environmental statement

related to operation of
**THE FORT ST. VRAIN NUCLEAR
GENERATING STATION**

OF
PUBLIC SERVICE COMPANY OF COLORADO
DOCKET NO. 50-267

August 1972

Figure II-1—AREA WITHIN 50-MILE RADIUS OF FORT ST. VRAIN NUCLEAR GENERATING STATION

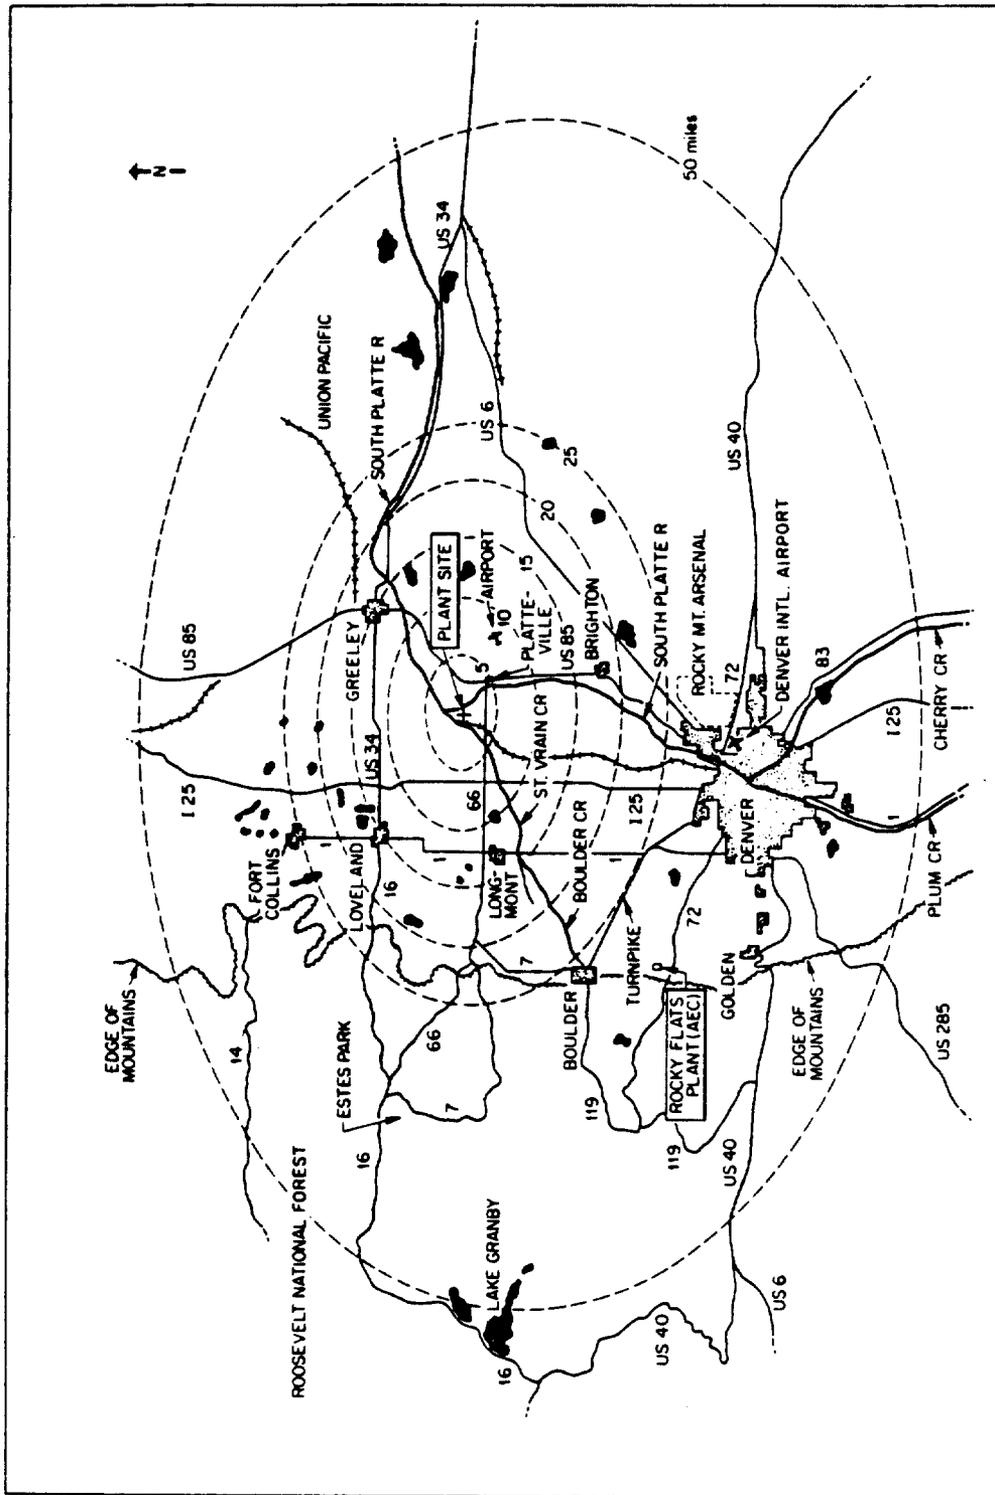
We have reviewed the Draft Environmental Impact Statement for the Fort St. Vrain Nuclear Generating Station. Our only comment is with regard to Figure II-1, page 12. In the upper left hand corner of the figure, "Roosevelt National Park" should be changed to "Roosevelt National Forest."

Figure II-8—LOCATION OF BIOLOGICAL SAMPLING STATIONS

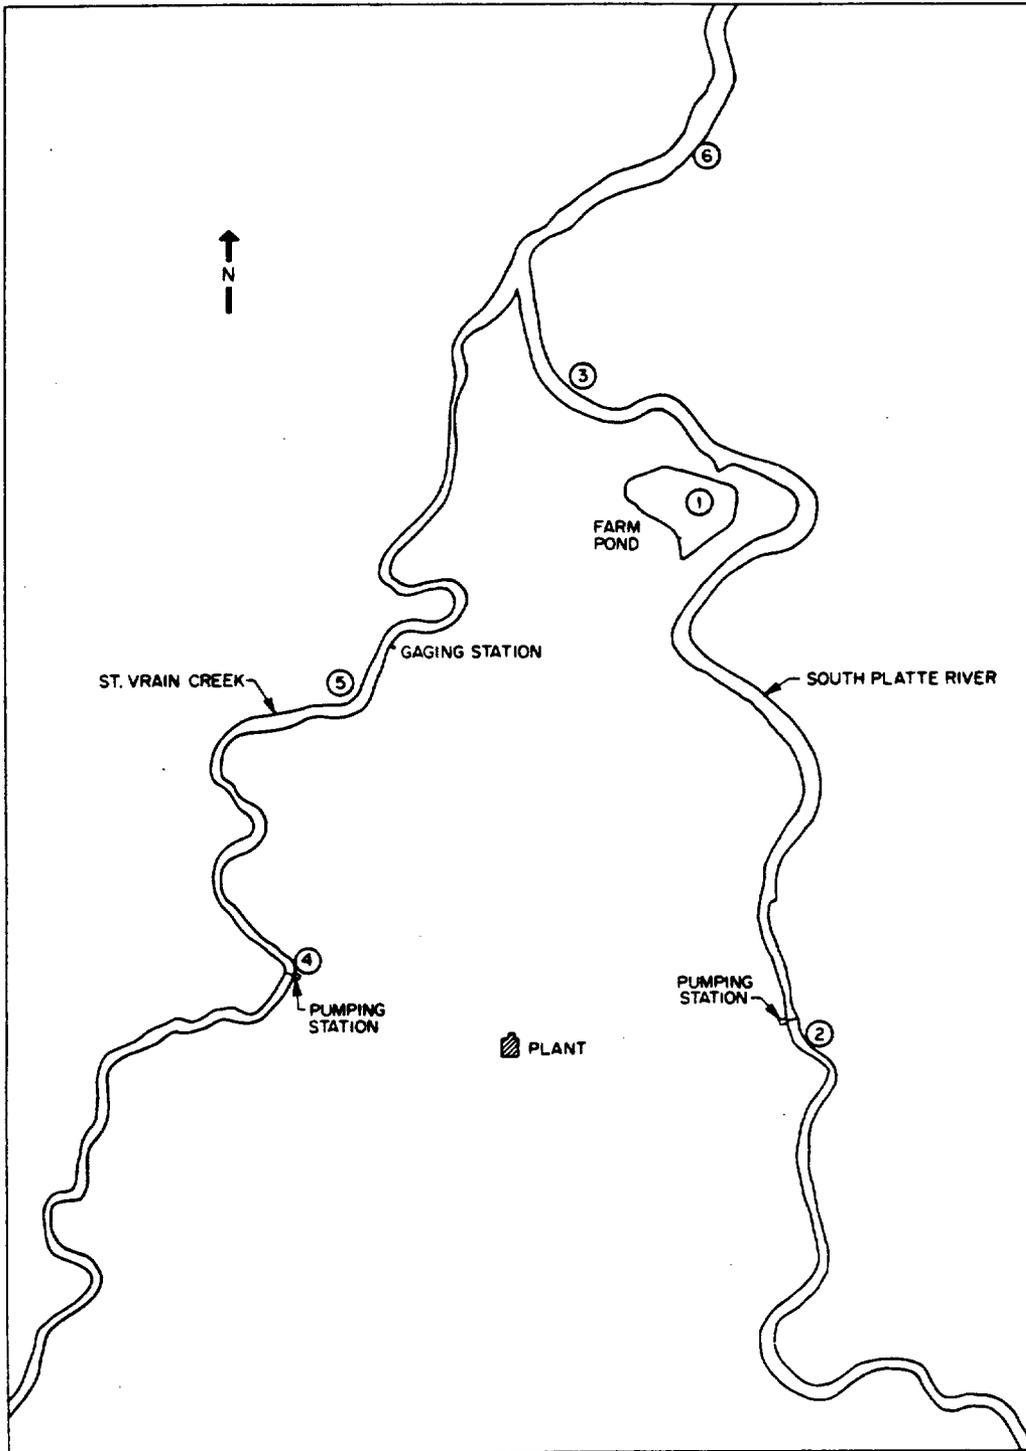
5. Figure II-8 (pg. 29) incorrectly represents the drainage path of the liquid radwaste that under normal operation will go through Goosequill Ditch to the farm pond. This should be corrected in the final statement. Mention should also be made of the concrete trough that runs from the Goosequill Ditch to the St. Vrain Creek and the potential for liquid radwaste to flow through this pathway.

It is correct that Figure II.8 does not show the normal drainage path. This figure was apparently based on an outdated background map; the primary purpose was to indicate locations of the biological sampling stations.
